UNITED STATES PATENT AND TRADEMARK OFFICE

APPLICATION NO.	FILING DATE	FIRST NAMED INVENTOR	ATTORNEY DOCKET NO.	CONFIRMATION NO.
09/471,981	12/23/1999	EMIKO IGAKI	MTS-3181US	8182

Office Action Summary

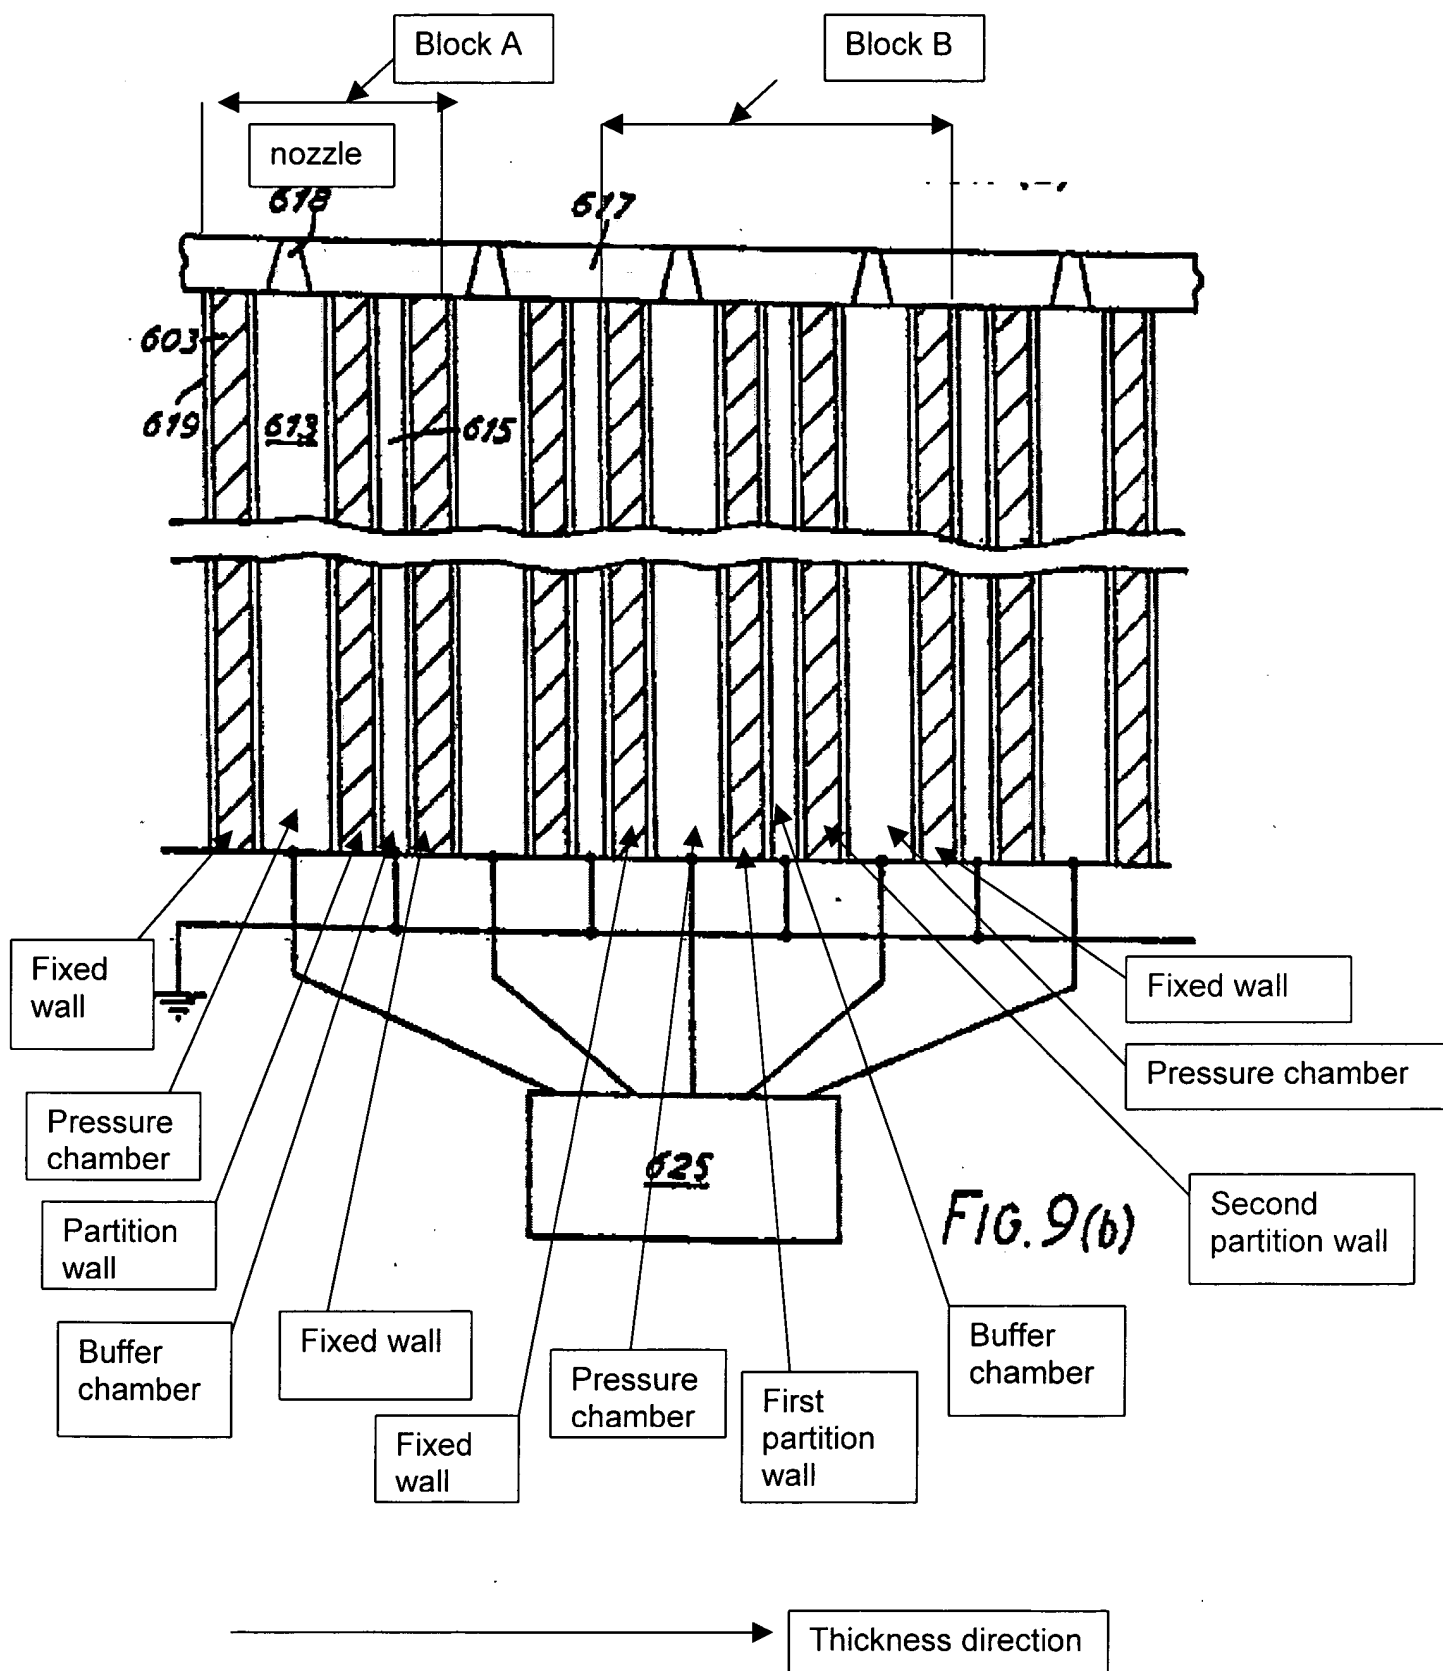
With respect to claim 1, Bartky et al. discloses an recording head comprising:

- One piezoelectric block having an ink pressure chamber (Fig.9b: element 613) communicating with a nozzle (element 618) for ejecting ink, a partition wall serving as a driving portion that includes a piezoelectric element, a pressure buffer chamber (element 615) and two fixed wall (Fig.9b)
- Ink pressure chamber, partition wall and pressure buffer chamber are respectively arranged in sequence along a thickness direction of piezoelectric block
- One of fixed walls is disposed adjacent to the ink pressure chamber and another fixed wall is disposed adjacent to the pressure buffer chamber (Fig.9b)

With respect to claim 4, Bartky et al. discloses an recording head comprising:

- One piezoelectric block (A) as shows in figure 9b, having an ink pressure chamber (A) communicating with a nozzle (A) for eject ink, a partition wall (A) serving as a driving portion that includes a piezoelectric element and at least tow electrodes (A) for driving the piezoelectric (A), a pressure buffer chamber (A) and two fixed walls (A),
- One piezoelectric block (B) as shows in figure 9b, having first and second ink pressure chamber (B) communicating with a nozzle (A) for eject ink, first and second partition wall (B) serving as a driving portion for one of the two ink pressure chamber, each partition wall includes a piezoelectric

element and at least two electrodes (B) for driving the piezoelectric (B), a pressure buffer chamber (B) and first and second fixed walls (B),

- Wherein the piezoelectric block (A) configured such that Ink pressure chamber (A), partition wall (A) and pressure buffer chamber (A) are respectively arranged in sequence along a thickness direction of piezoelectric block,
- One of the fixed walls (A) is disposed adjacent to the ink pressure chamber (A) and another fixed wall is disposed adjacent to the pressure buffer chamber (A),
- Wherein the piezoelectric block (B) configured such that Ink pressure chamber (B), partition wall (B) and pressure buffer chamber (B) are respectively arranged in sequence along a thickness direction of piezoelectric block,
- One of the fixed walls (B) is disposed adjacent to the first ink pressure chamber (B) and another fixed wall is disposed adjacent to the second pressure chamber (B)

AAPA discloses in figure 17:

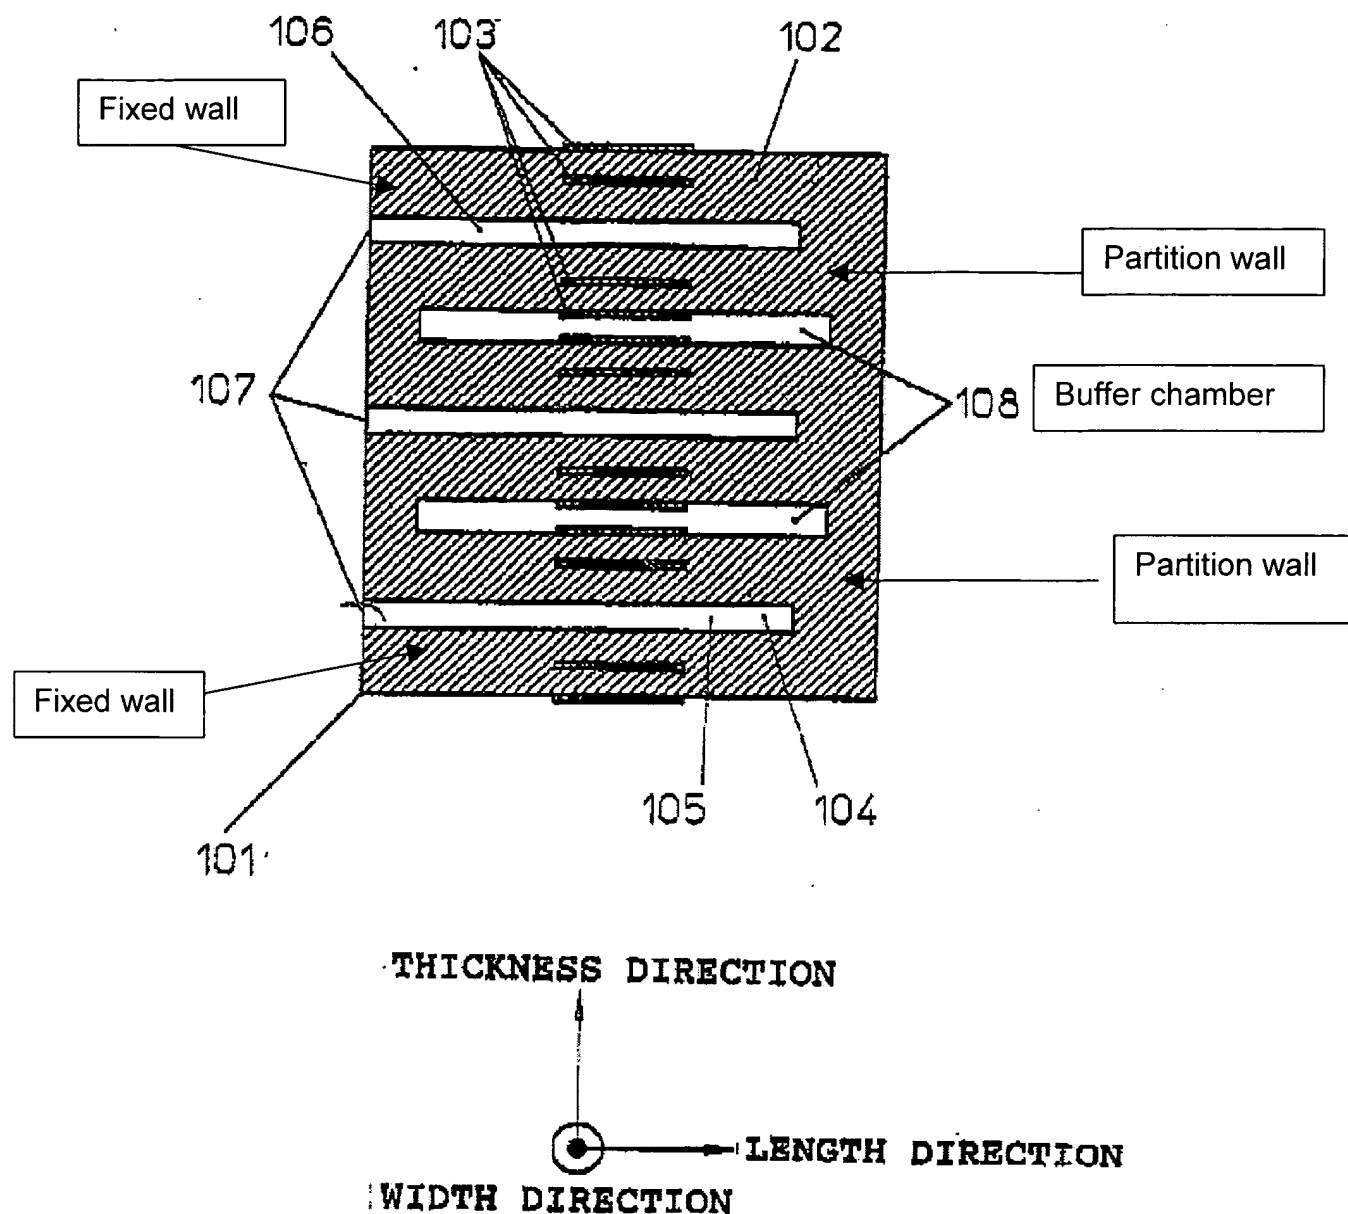
- an ink-jet recording head comprising at least one piezoelectric block (B);
- Each piezoelectric block (B) has first and second ink pressure chambers (106);

- each pressure chamber communicating with a nozzle (107) first and second partition walls (Fig.17);
- each partition wall serving as a driving portion for one of the ink pressure chambers, each partition wall including a piezoelectric element and two electrodes ((Fig.17) for driving said piezoelectric element;

- a pressure buffer chamber (108) and first and second fixed walls (Fig.17);
- The first fixed wall, the first ink pressure chamber, the first partition wall, the pressure buffer chamber, the second partition wall, the second ink pressure chamber, and the second fixed wall are arranged in sequence along a thickness direction (Fig.17) and surface of the electrodes are oriented perpendicular to the thickness direction, the driving portion is polarized in the thickness direction and perpendicular to the surfaces of the electrodes (Fig.17), at last one electrodes (103) for controlling, by

bending of the electrode, whether the partition wall bend toward a side of the ink pressure chamber or bends towards a side of the pressure buffer

- at least one of the electrodes is embedded in the wall (103);
- a plurality of these blocks, arranged in the thickness direction.
- the pressure buffer chambers are all closed on a side at which the nozzle communicating with the ink pressure chamber is open (see Fig. 4).
- there are two electrodes per partition wall, one of which is exposed to the pressure buffer and the other exposed to the ink pressure chamber;
- a portion at which the electrodes on a partition wall face each other is included in a portion at which the ink pressure chamber and pressure buffer chamber face each other (Fig.17);
- the piezoelectric block is an integrally sintered one piece block structure;
- the distance between nozzles appears to be constant (Fig.17).
